Subject: **ELONGATION OF VERTICAL SIZE WHEN
 CCIR INPUT IS USED**

Model: **PVM-95**

Serial No: **1,000,304–1,001,283**

Figure 1

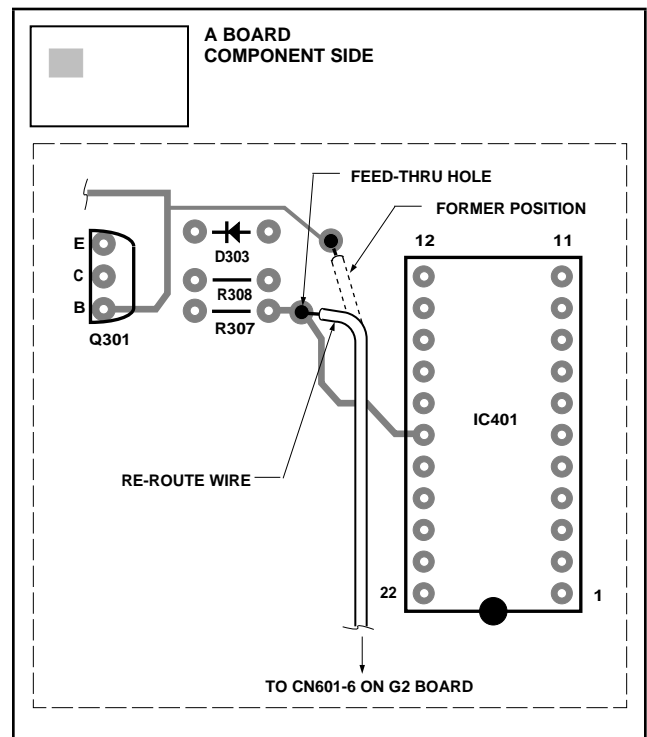
In some of the above units, vertical picture size may be lengthened by approximately 20% when a CCIR signal is input. To correct this condition, perform the following modification procedure.

1. Remove wire from Q301-B and re-solder it at the feed-thru hole near IC401-17 as shown.
2. Adjust RV301 (V. SIZE). (Refer to Service Manual, page 10.)

NOTE: After rewiring, vertical size may be lengthened by approximately 30% when EIA signal is input. Always adjust RV301 after rewiring.

3. Move the wire from CN601-6 on the G2 board to the feed-thru hole shown in Figure 1.
